United Nations ST/SG/AC.10/C.3/2015/2

Forty-seventh session
Geneva, 22 – 26 June 2015
Item 2 (c) of the provisional agenda
Explosives and related matters: Review of tests in parts I and II of the Manual of Tests and Criteria

Manual of Tests and Criteria

Recommendations for improvement of series 8 (c) Koenen Test

Yield strength of DC04 sheet steel
$\dot{\varepsilon} = 1\,\mathrm{s}^{-1}$
Yield stress (MPa)
Effective plastic strain
25°C
200°C
315°C
425°C
540°C
650°C
760°C
880°C
1.000°C
0
100
200
300
400
500
600
700
0.00
0.05
0.10
0.15
0.20
0.25
0.30
0.35
0.40

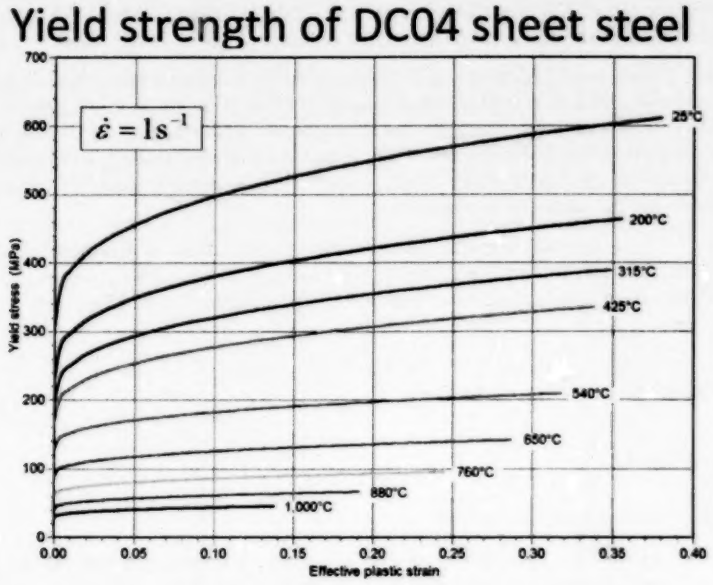
9. The type of steel used for the tube that contains the substance is DC04 steel sheet. The properties of this steel as a function of temperature are shown in the annex to this document. At the time of incorporation of the Koenen Test into the Manual of Tests and criteria, the commercial explosives were very similar to those used for the development of the test. From the chart it can be seen that the yield stress of that steel for an effective plastic strain of 0.20 drops from 550 MPa to 350 MPa when heated to 315°C, showing that this type of steel does not retain its strength on heating.
